## PICKLEBALL NOVI JSP23-15

Public Hearing at the request of Pickleball Novi for JSP23-15 for Preliminary Site Plan, Special Land Use Permit, Woodland Permit, and Stormwater Management Plan. The subject property is approximately 3.65 acres and is located north of Nine Mile Road on the east side of Venture Drive in the I-1, Light Industrial District. The applicant is proposing to build an indoor recreation facility with accessory uses.

## PLANNING REVIEW

2<sup>nd</sup> Revised Preliminary Site Plan

SHEET  
Tree Preservation Plan

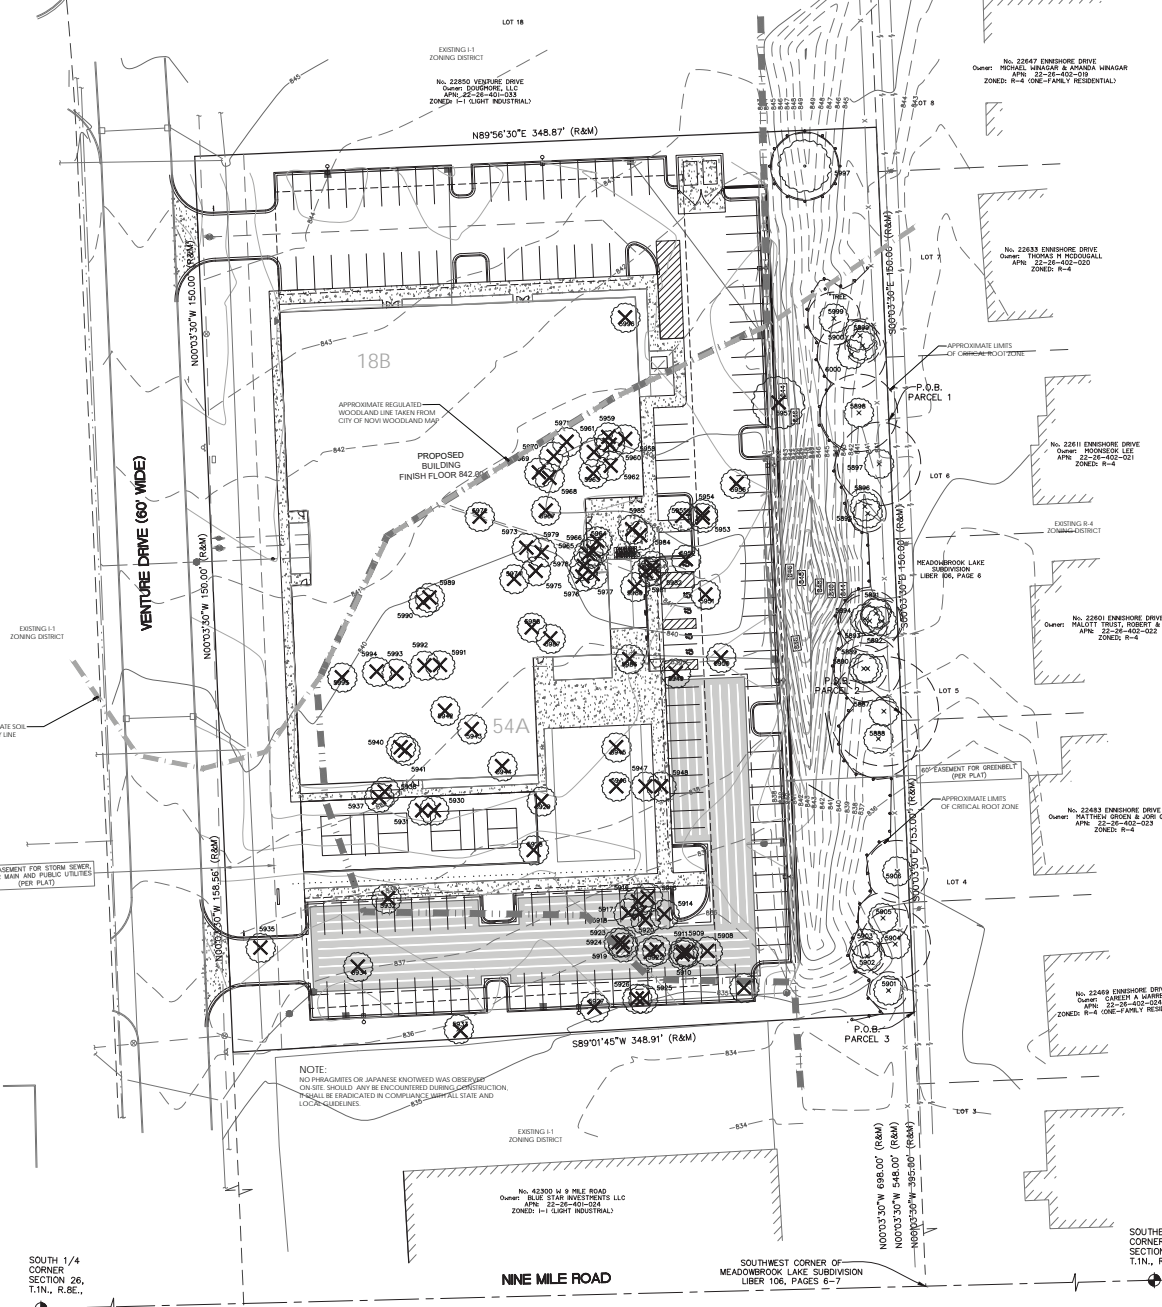
3. **Sheet L1.** Revise sheet L1 to include tree protection fencing around tree tag #5933 (site photo 2). This tree is indicated for preservation on sheet SP-01a, "List of Surveyed Trees".

**SHEET:**  
 Landscape Plan

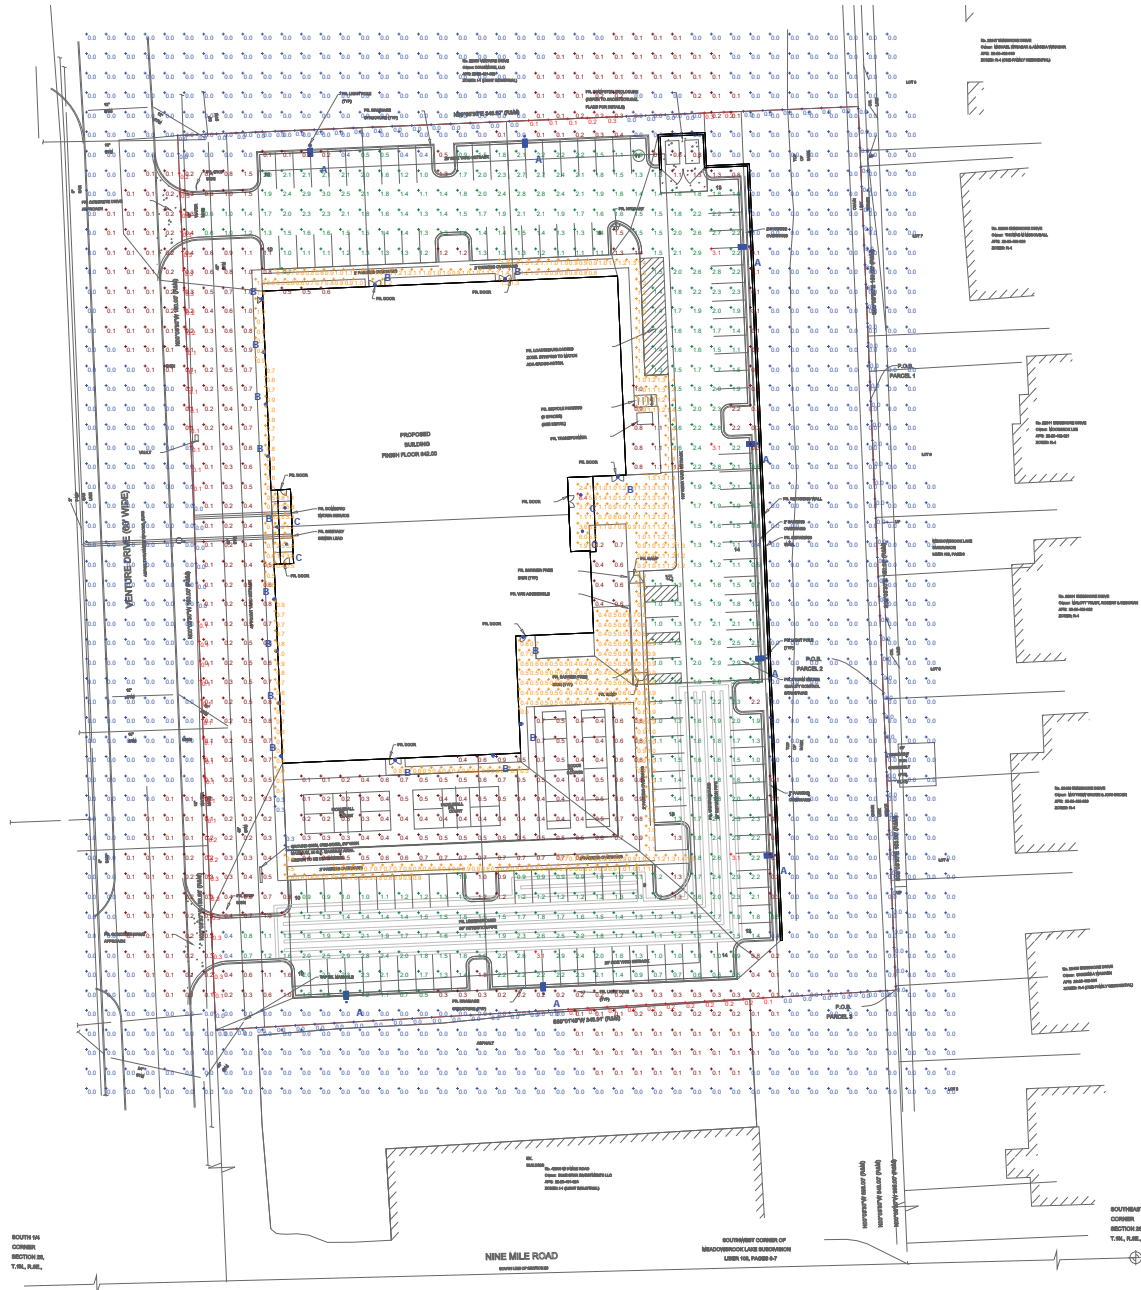
**\*Note Sheets L1 and L2 incorrectly calculated the tree replacement credits required for multi-stem trees – see Woodland Review Comment #4 – the total number of replacement credits required is 179 not 176.**

4. **Sheets L1 and L2.** The calculation for tree replacement credits of multi-stem trees is incorrect. To calculate, sum the diameter of all multi-stem trees (393" diameter) and divide by 8. **Revise the plant schedule on sheet L2 "Landscape Plan" and the replacement summary table on sheet L1 "Tree Preservation Plan"** to reflect 49 multi-stem tree replacement credits are required.

TITLE: Roof Plan, Study Section

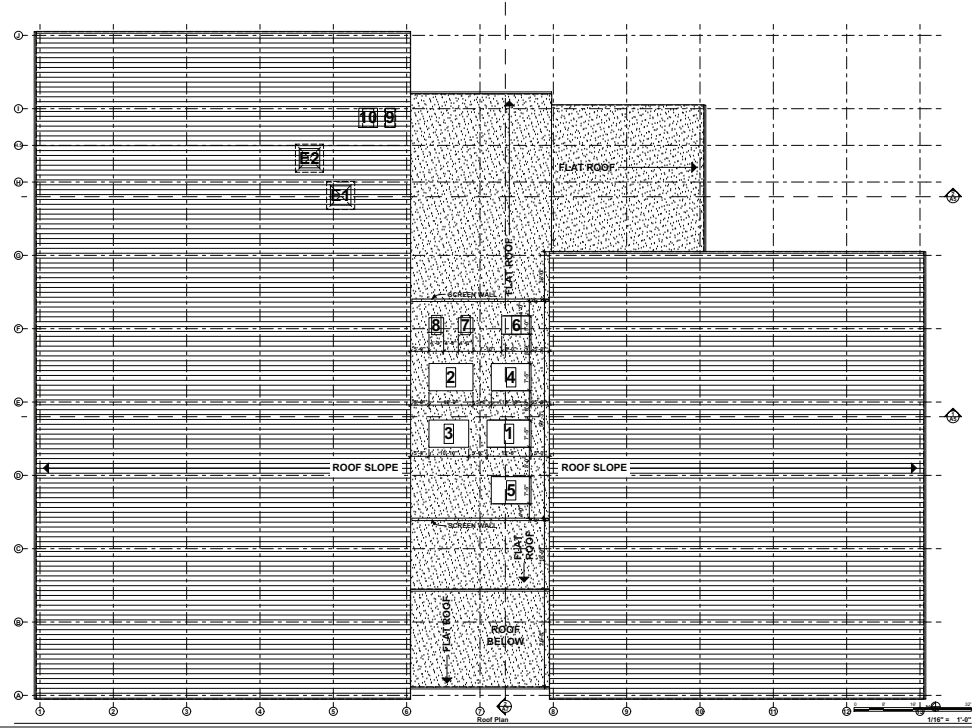
As shown above, all proposed façade materials are in full compliance with the Façade Ordinance. The building cross section on sheet A-7 indicates that screening of all HVAC units has been efficiently integrated into the buildings design. The dumpster enclosure is proposed to be constructed of Split Faced Concrete Masonry Units (CMU) to match the building. The applicant should provide color samples of all façade materials at the time of the Planning Commission meeting.

### EXHIBIT 9

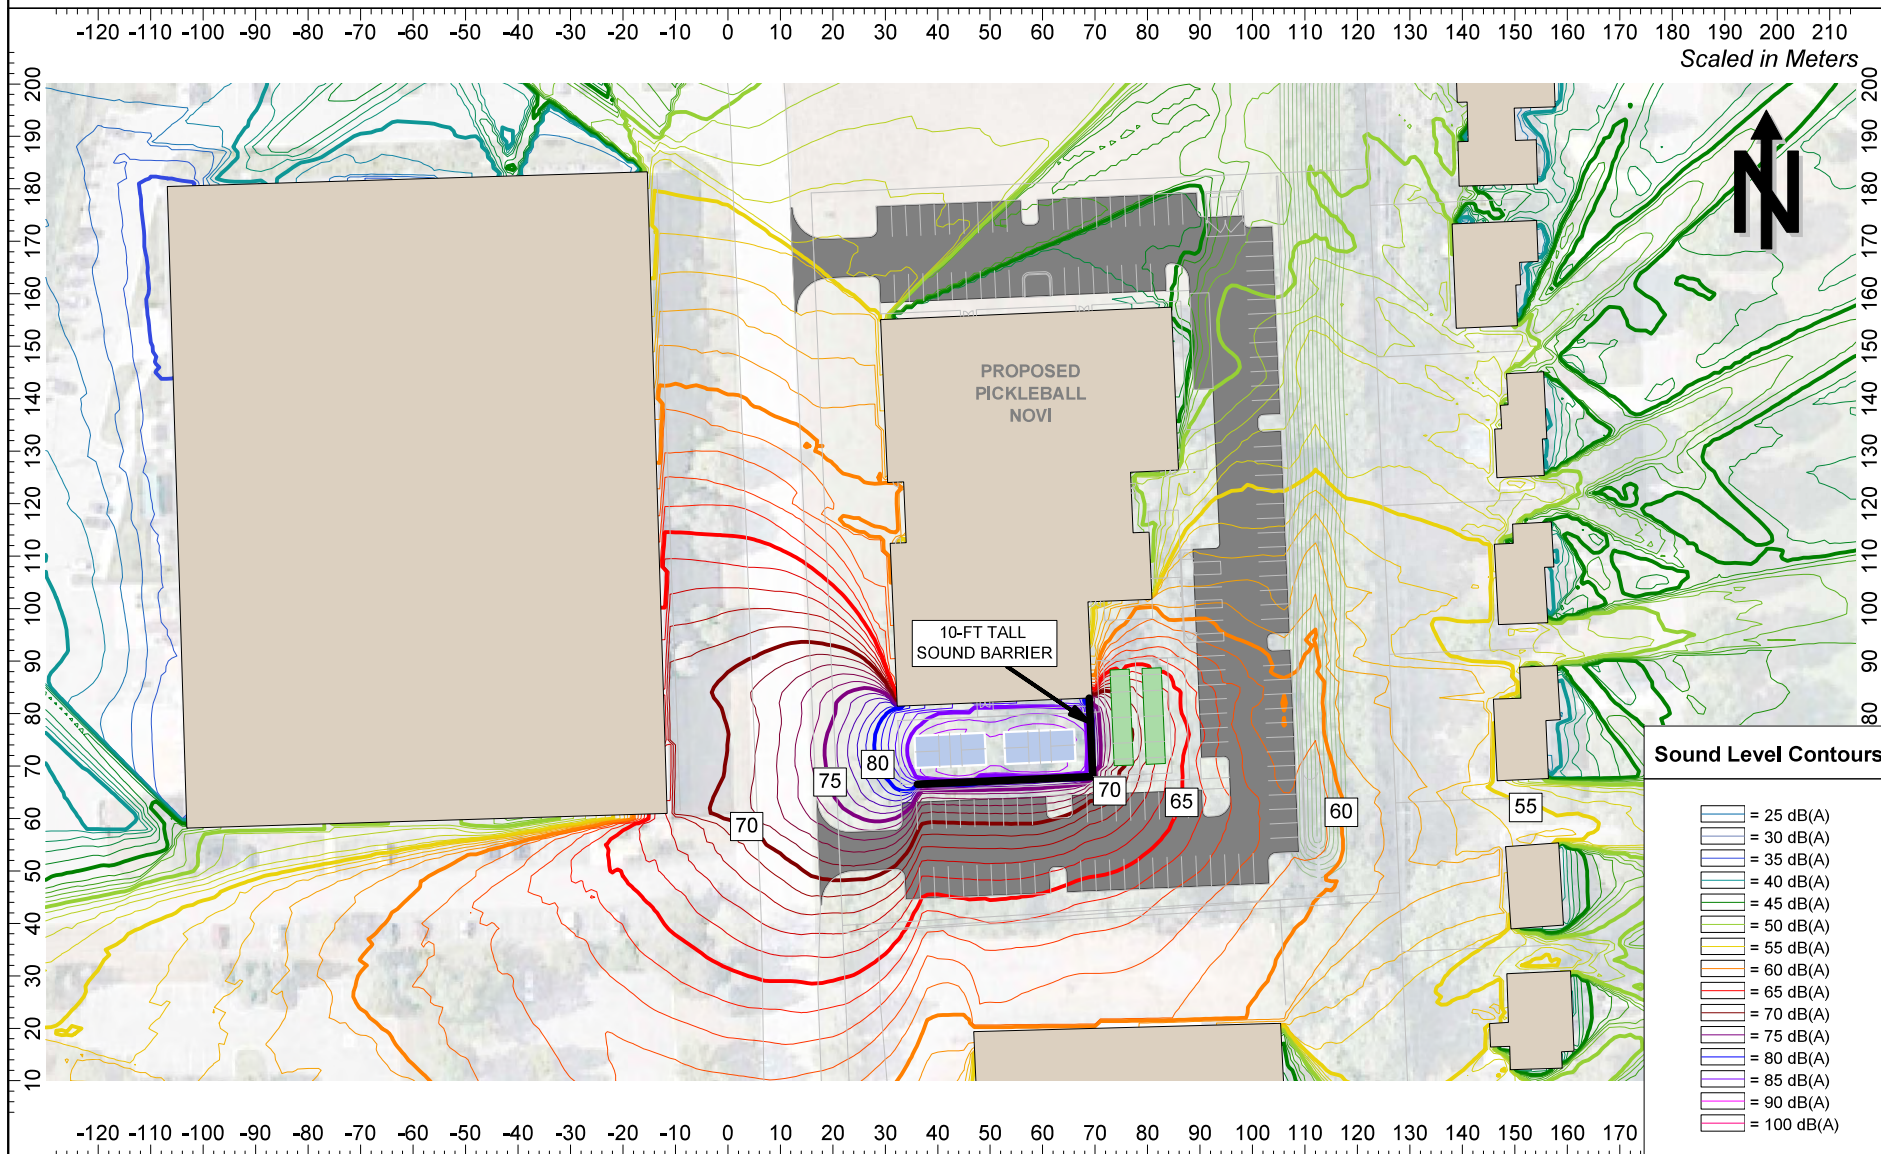
Per Exhibit 9 of the sound study prepared by Kolano and Saha Engineers, a 10-foot sound barrier will be installed on three sides of the outdoor pickleball courts. The courts will not be utilized after 10:00 PM. A sample of the sound-deadening material has been submitted to the planning department.

The best way to reduce the pickleball sound levels at the residences is to put a sound barrier near the pickleball courts. Through modeling trials, we determined that a 10-foot-tall sound barrier to the east and south of the pickleball courts will provide enough shielding to reduce the maximum pickleball noise below the ordinance limits. **EXHIBIT 9** provides the modeling iteration of the pickleball courts with the 10-foot sound barrier.
